## Important Information 97 – Sales

### SAF low-maintenance ballrace turntable update.

#### SAF double-row ballrace turntable design update

Tel. +49 6095 301-0 · info@safholland.de · 2017-08-01 · XL-SA10097WI-en-DE Rev B

#### Introduction of the new SAF-HOLLAND double-row ballrace turntable

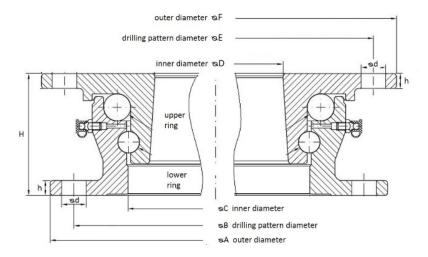
Due to the Customers' demand for 20t ballrace turntable with outer diameter of **a1208 mm**, SAF-HOLLAND is introducing a new model, P/N 1038 30 000087 0 with the following dimensions:

Туре	Part No.	Axial load (kN)	Weight (kg)	A (mm)	B (mm)	C (mm)	D (mm)	E (mm)	F (mm)	bø (mm)	h (mm)	H (mm)	Drill template
BR-S-20- 12a-U-2-08	103830 0000870	200	104	1195	1160	1080	1040	1174	1208	18	11	90	8
